Subject: MHI's Response to US-APWR DCD RAI No. 297-2287 Revision 2

MHI's Response to US-APWR DCD RAI No. 297-2287 Revision 2

**US-APWR Design Certification
Mitsubishi Heavy Industries
Docket No. 52-021**

RAI NO.: NO. 297-2287 REVISION 2
SRP SECTION: 15 – INTRODUCTION – TRANSIENT AND ACCIDENT ANALYSES
APPLICATION SECTION: 15.0.0
DATE OF RAI ISSUE: 5/04/2009

**Figure 15.0.0-3.1 Reactor Power versus Time with and without LOOP
Uncontrolled Control Rod Assembly Withdrawal at Power
- DNBR Analysis (HFP, BOC, 75 pcm/sec)**

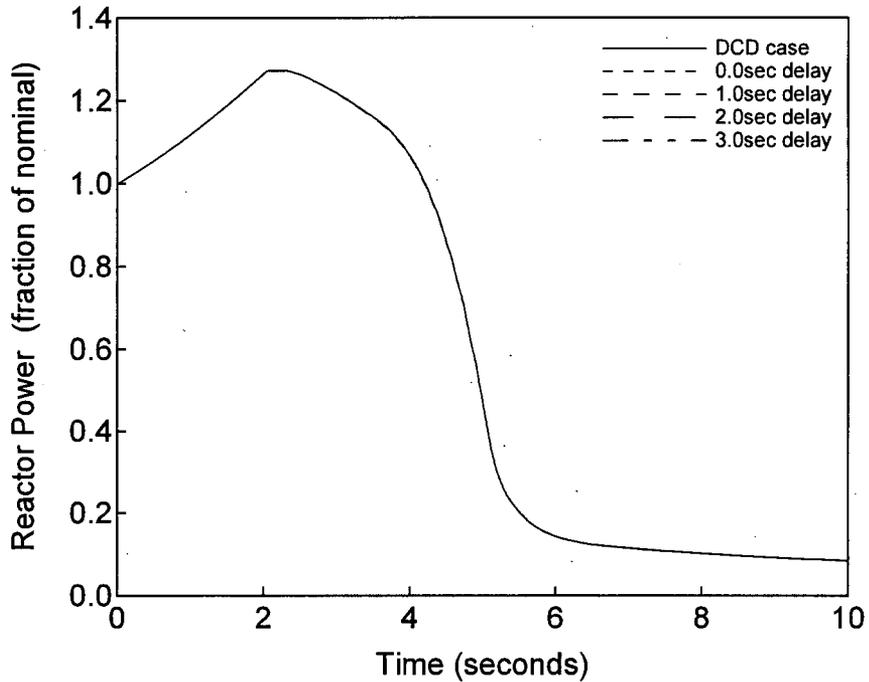
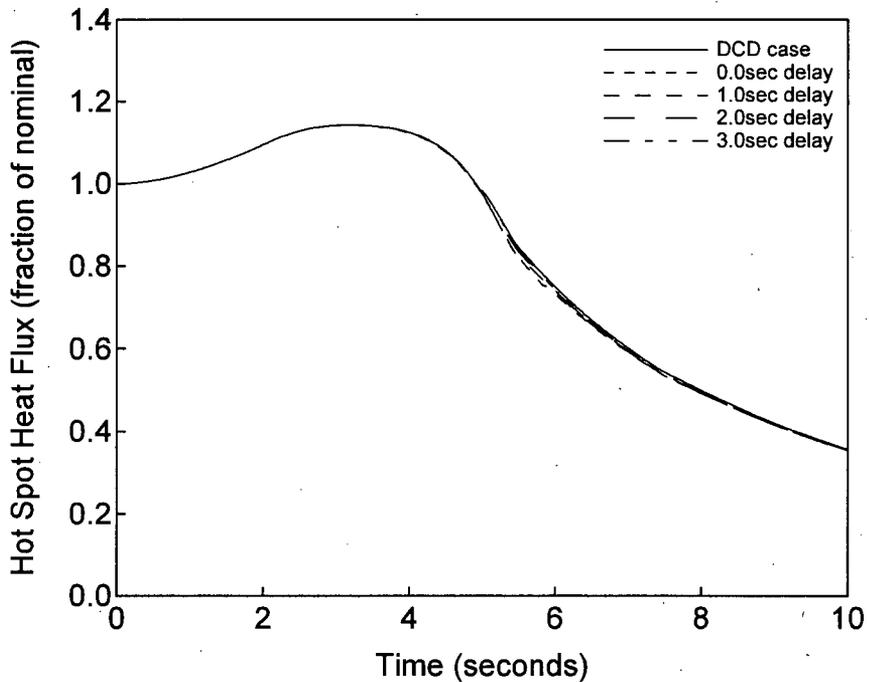
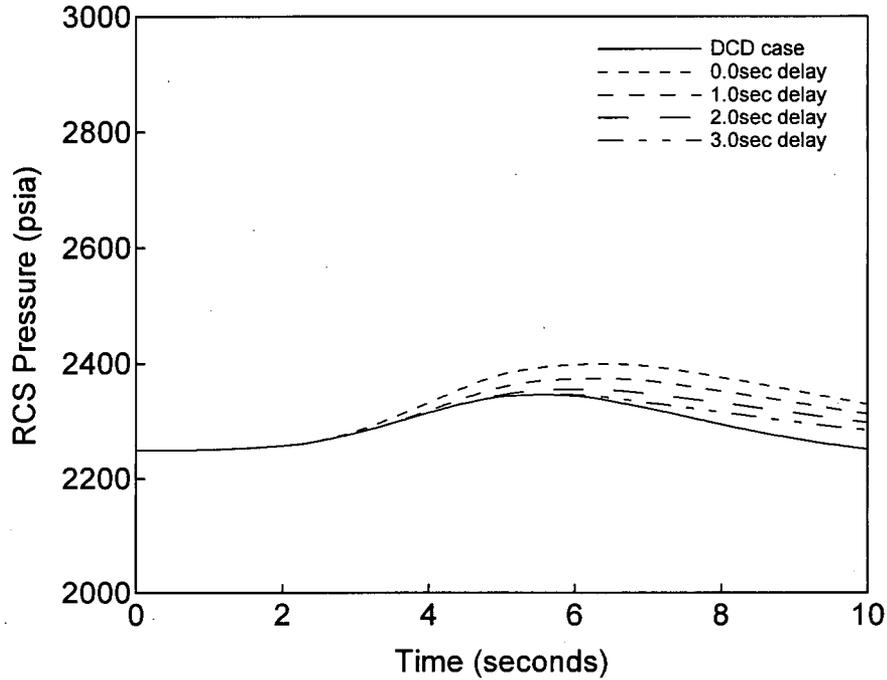
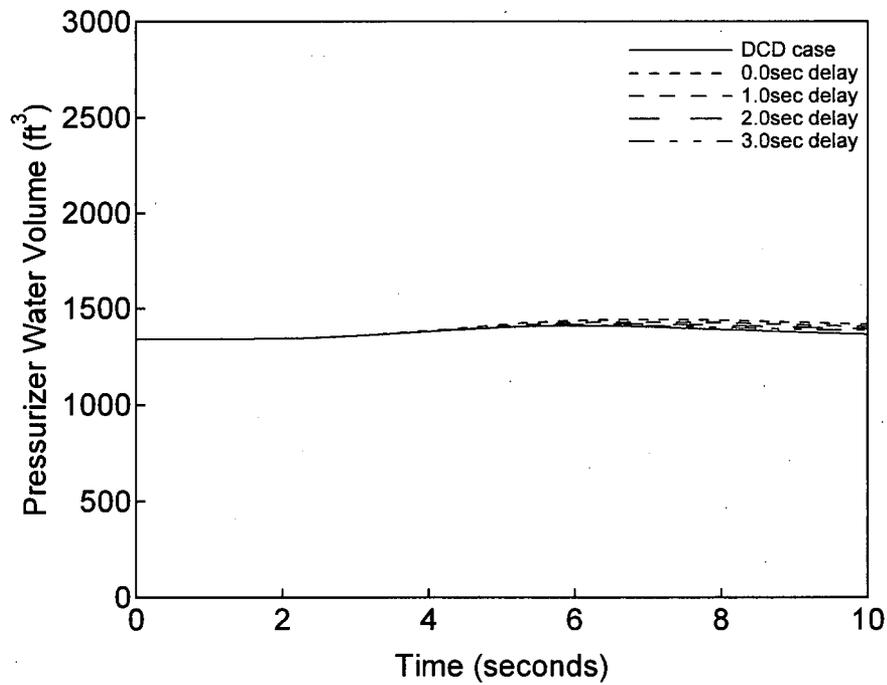
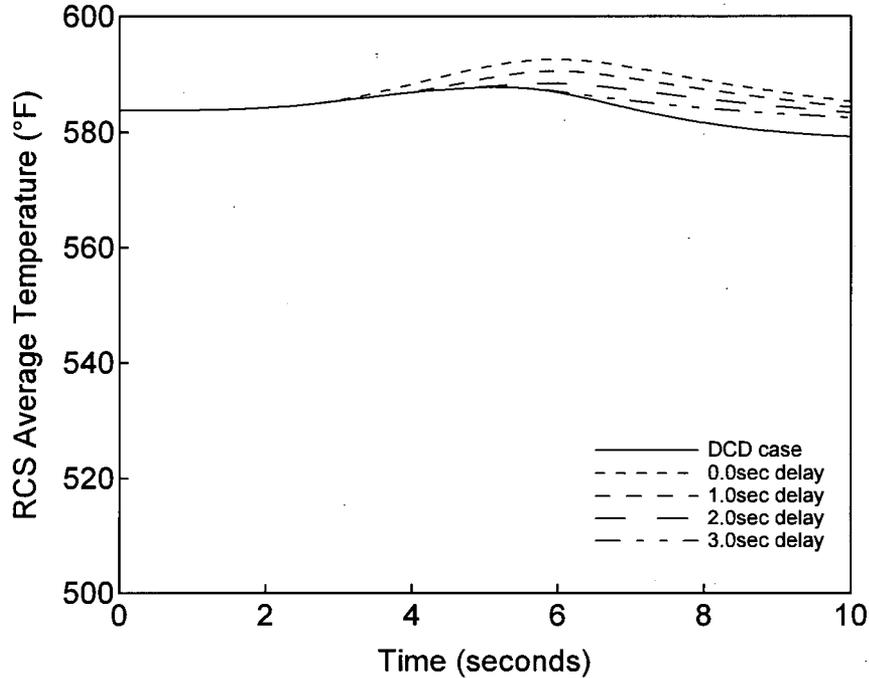
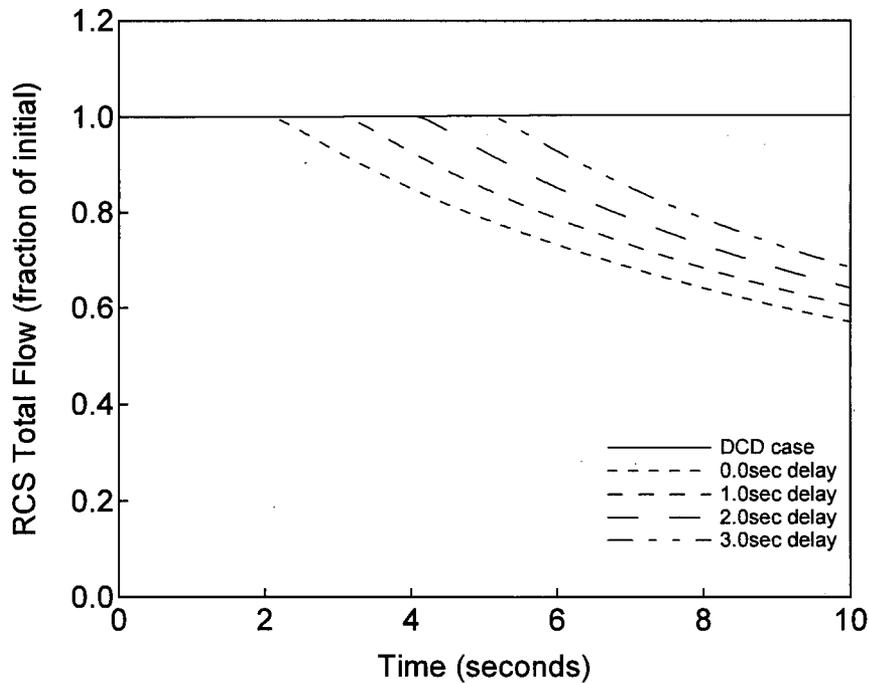
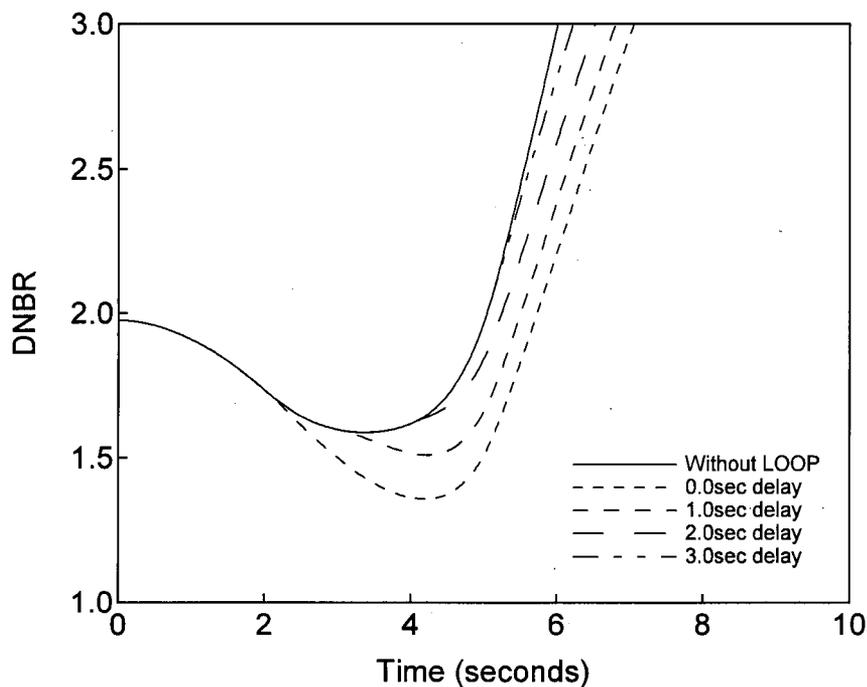
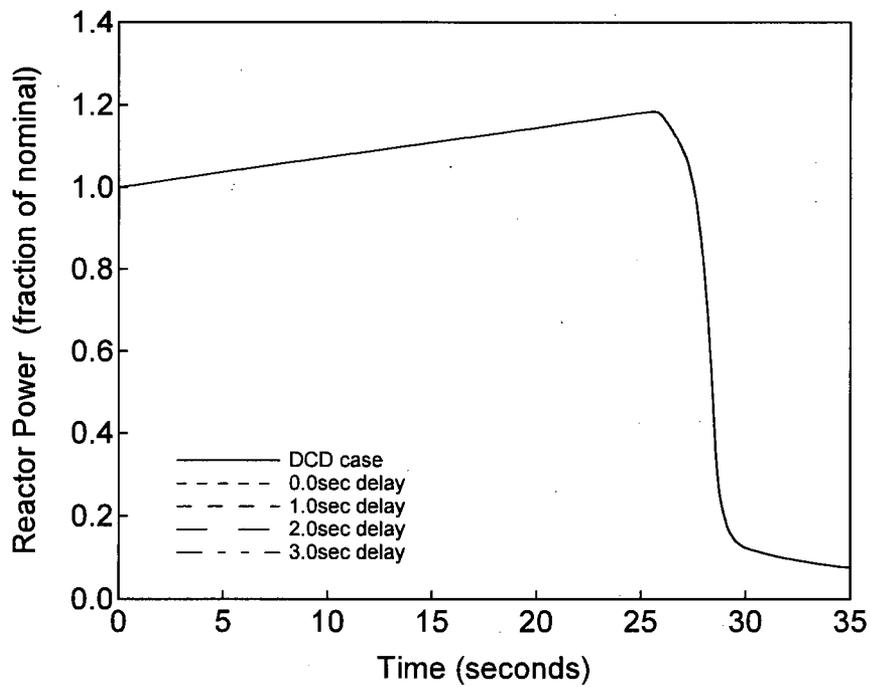
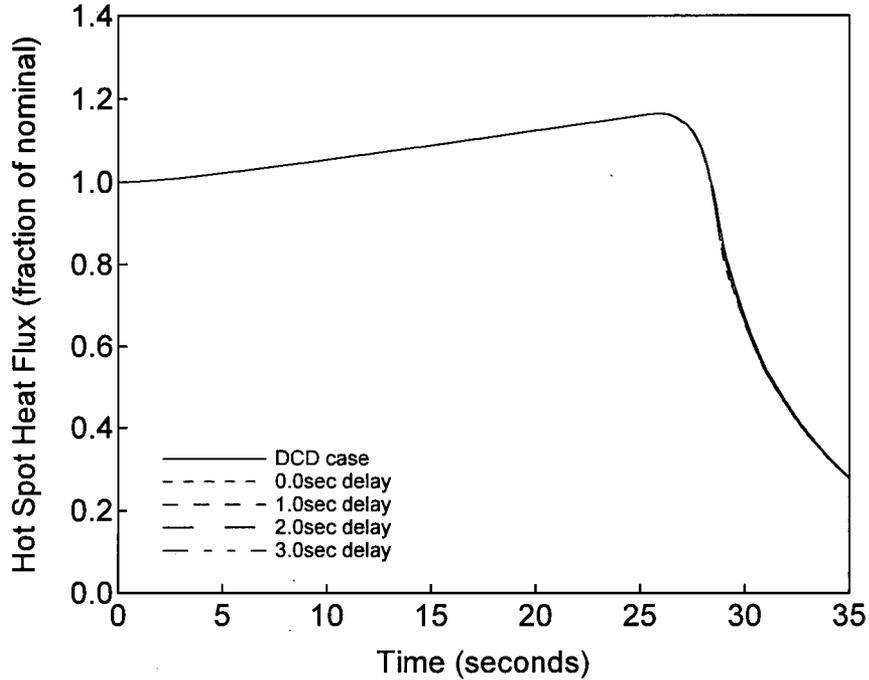
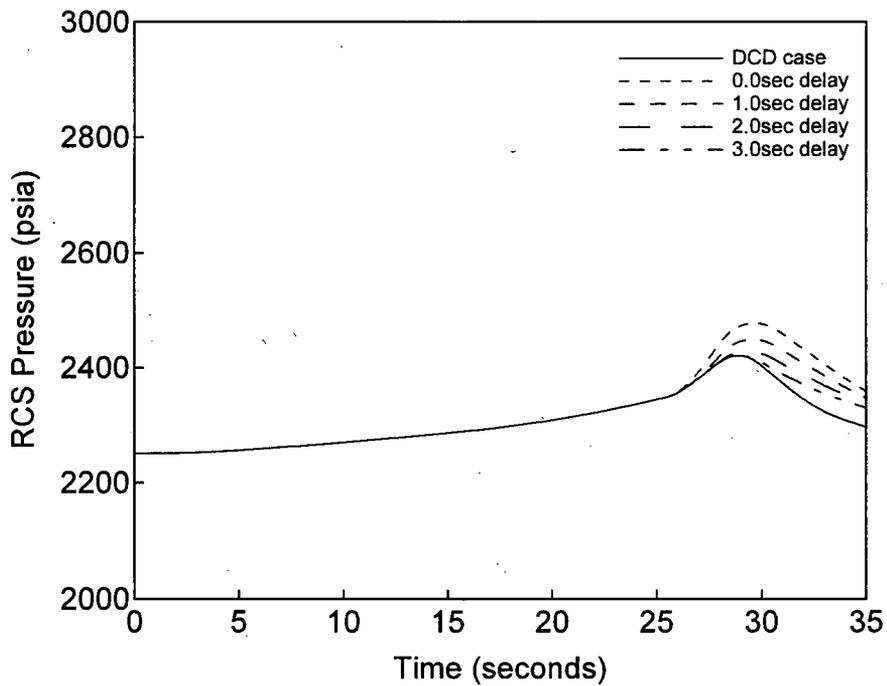
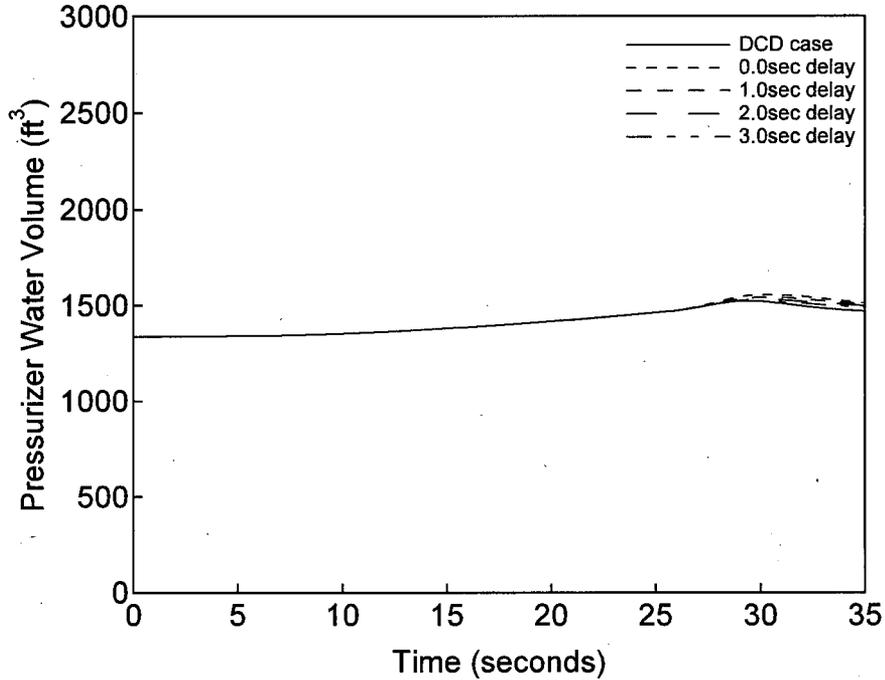
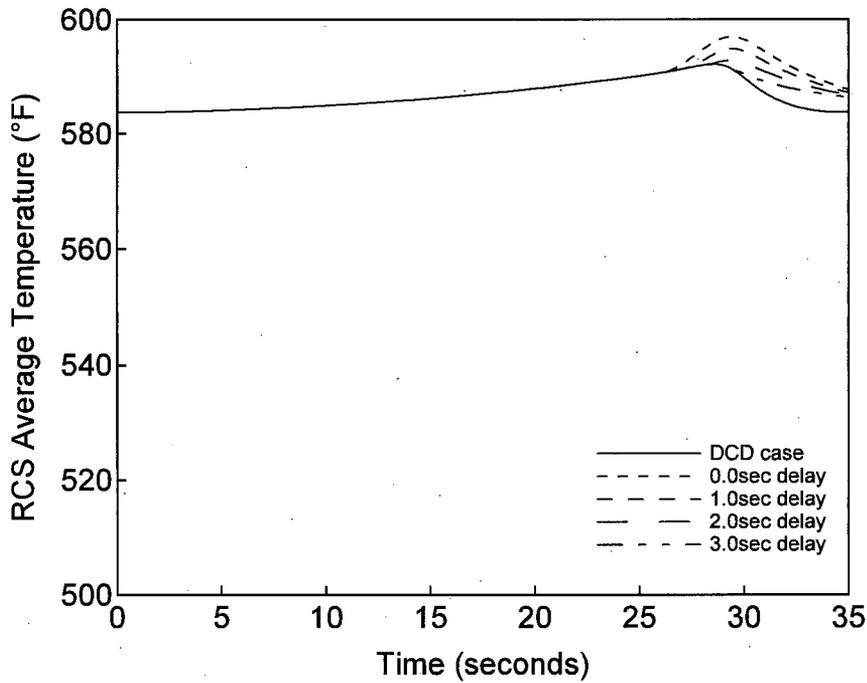
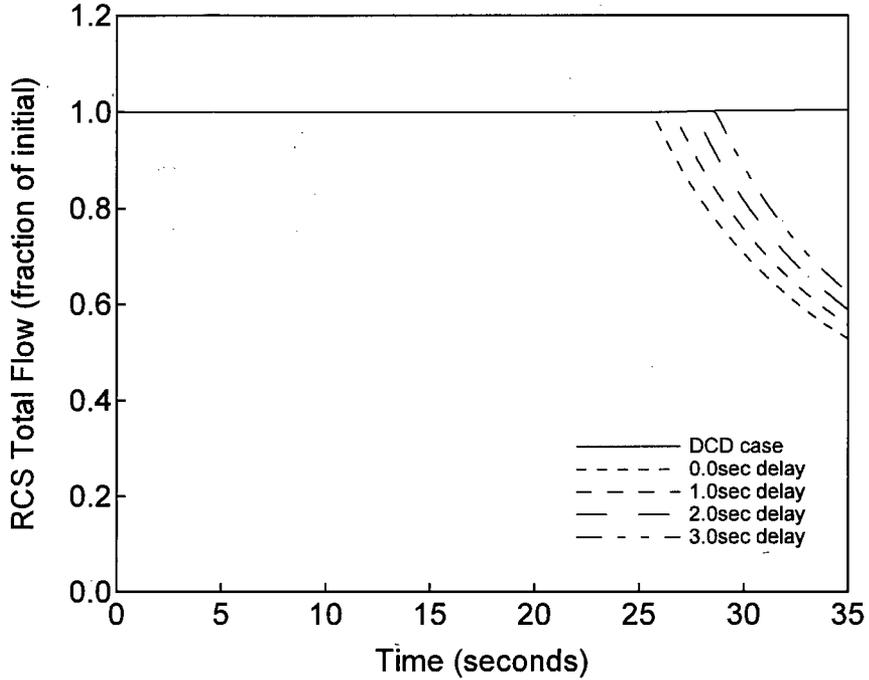
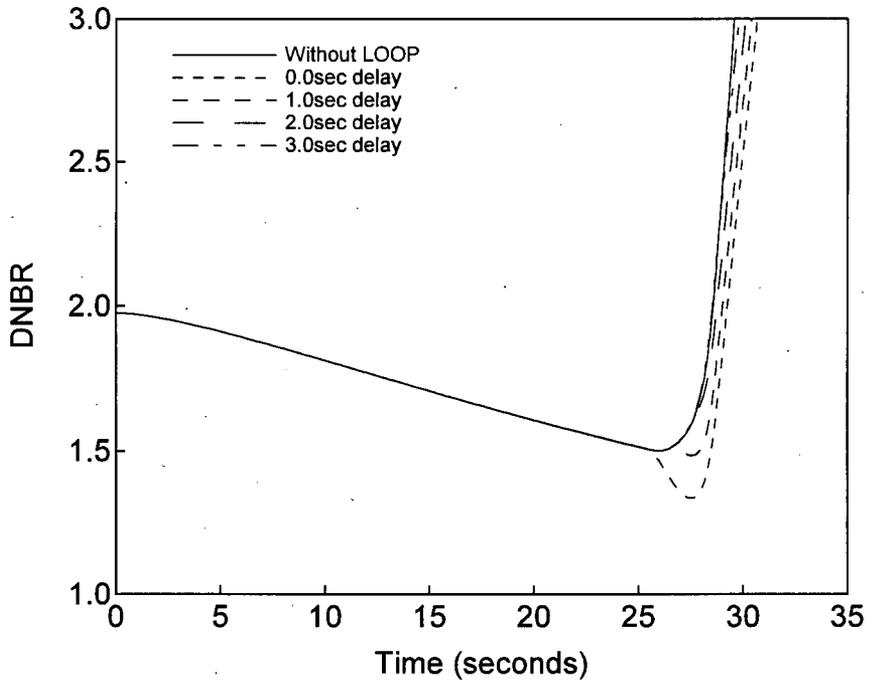
In DCD Section 15.0.0.7, the applicant presents arguments concerning the timing of a LOOP with respect to the timing of reactor trip and RCP coast down. By assuming a time delay in the onset of a LOOP, the onset of DNBR is decoupled from the availability of offsite power because the rods are inserted to the dashpot by the time the LOOP is initiated; therefore, the RCPs continue to run until the rods have been inserted in the core. This argument repeats itself throughout many Chapter 15 scenarios, allowing for the neglect of any LOOP consequences. Please provide more substantial arguments in defense of this assumed time delay, supported by sensitivity calculations that directly address this issue. (see also Question 15.1.2-1).

The results of the DNBR sensitivity analysis of these four events validate the assumption described in DCD Subsection 15.0.0.7 (and reiterated in event-specific subsections) that, with a 3 second delay between the turbine-generator trip and LOOP, the minimum DNBR is the same for the case with and without LOOP. The results of this sensitivity also show that there is some available margin in the delay time assumed since the minimum DNBR is the same for the case with LOOP assuming a 2 second delay and without LOOP. In addition, while the minimum DNBR for the 1 second delay cases were slightly worse than the cases without LOOP, the DNBR remained above the safety analysis analytical limit. Since the four events selected for this sensitivity analysis were representative DNBR events in Chapter 15, the remaining DNBR analysis in Chapter 15 would also be adequate even assuming a 1 second delay (excluding those events that already violated the DNBR limit, such as the RCP rotor seizure). Although the results showed that the two 0 second delay RWP cases result in a minimum DNBR below the acceptance limit, the US-APWR DCD contains COL Item 8.2(11) which requires that the COL applicant perform a grid stability analysis to confirm that the LOOP occurs at 3 seconds or greater. This is also described in the response to Question 15.0.0-4 of this RAI.
